SUNDRY NOTICES AND REPORTS ON WELLS (DO NOT USE THIS FORM FOR PROPOSALS TO DRILL OR TO DEEPEN OR PLUG BACK TO A DIFFERENT RESERVOIR. USE "APPLICATION FOR PERMIT" (FORM C-101) FOR SUCH PROPOSALS.)		WELL API NO. 30-025-30131
1. Type of Well: Oil Well ☒ Gas Well ☐ Other ☐		5. Indicate Type of Lease STATE ☐ FEE ☒
2. Name of Operator RAM ENERGY LLC		6. State Oil & Gas Lease No. 313857
3. Address of Operator 2100 S UTICA AVE., SUITE #175, TULSA, OK 74114		7. Lease Name or Unit Agreement Name WEST DOLLARHIDE QUEEN SANDS UNIT
4. Well Location Unit Letter <u>I</u> : <u>970</u> feet from the <u>E</u> line and <u>1360</u> feet from the <u>S</u> line Section <u>31</u> Township <u>24S</u> Range <u>38E</u> NMPM County <u>LEA</u>		8. Well Number <u>92</u>
11. Elevation (Show whether DR, RKB, RT, GR, etc.) 3133 KB		9. OGRID Number 309777
		10. Pool name or Wildcat 18810

WELLBORE DIAGRAM
WEST DOLLARHIDE QUEEN SAND UNIT #92
CURRENT
API: 30-025-30131

**CONDITIONS OF APPROVAL
FOR PLUGGING AND ABANDONMENT
OCD - Southern District**

Operator: RAM ENERGY LLC 5100 East Skelly Drive Tulsa, OK 74135	OGRID: 309777
	Action Number: 48080
	Action Type: [C-103] NOI Plug & Abandon (C-103F)

WELLBORE DIAGRAM
WEST DOLLARHIDE QUEEN SAND UNIT #92
PROPOSED
API: 30-025-30131

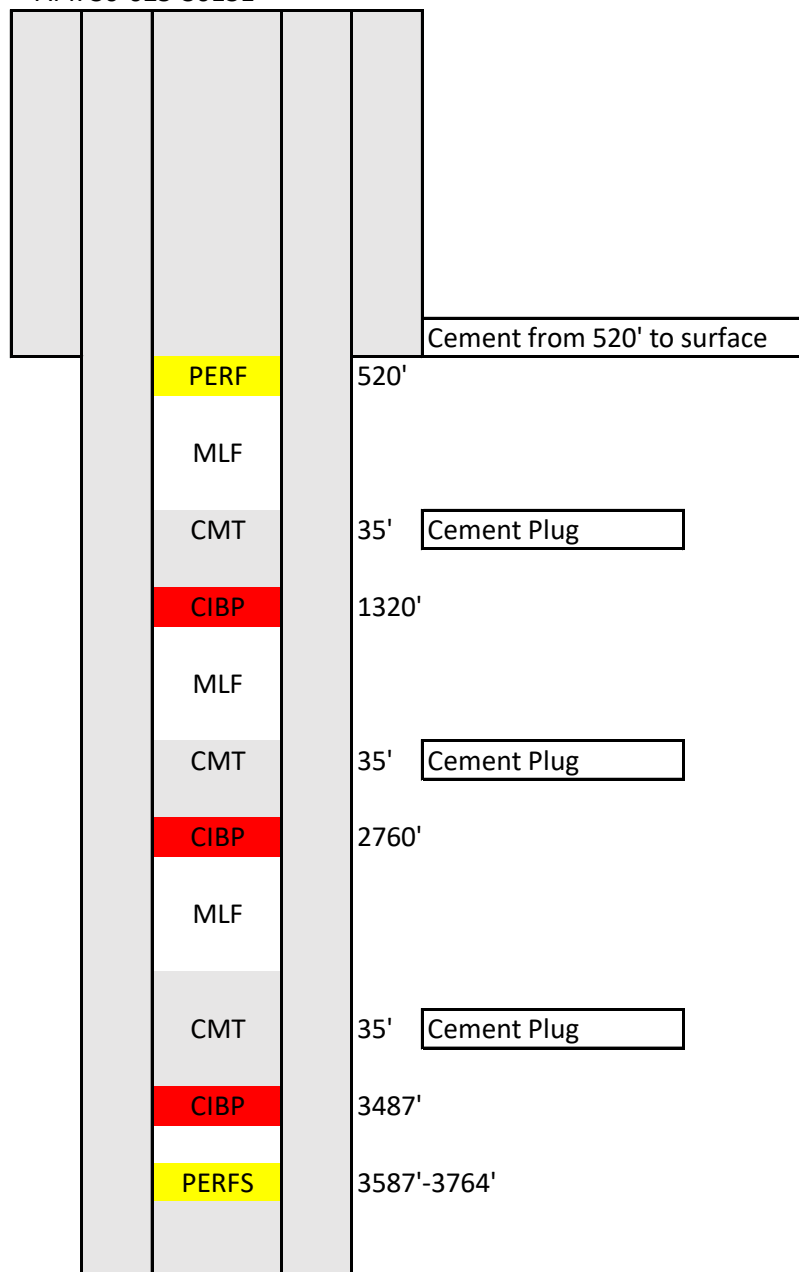
Circ MLF Pressure test
 csg

4" diameter 4' tall Above Ground Marker
